## MARK-3<sup>®</sup> 185cc Gudgeon Pin

### TECH-NOTE

Publication Number: 701282, Rev.1 All rights reserved. Printed in Canada.

#### New gudgeon pin

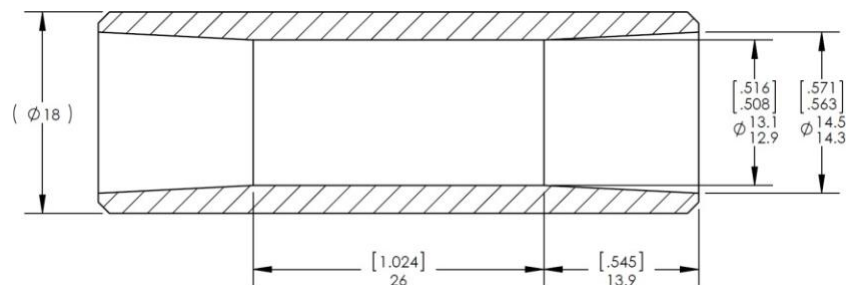
A new gudgeon pin has recently been introduced on the MARK-3. The change became effective in March 2015. The new gudgeon pin is fully backwards compatible.

The new gudgeon pin has a more modern design. Its inner diameter is tapered: the pin is thinner at the edges and becomes thicker towards the center where the forces and stresses are greater. The result is a new gudgeon pin that is 19% lighter than the previous design. The lighter weight helps increase the durability of the crankshaft and bearings. The item number (800030) remains unchanged.
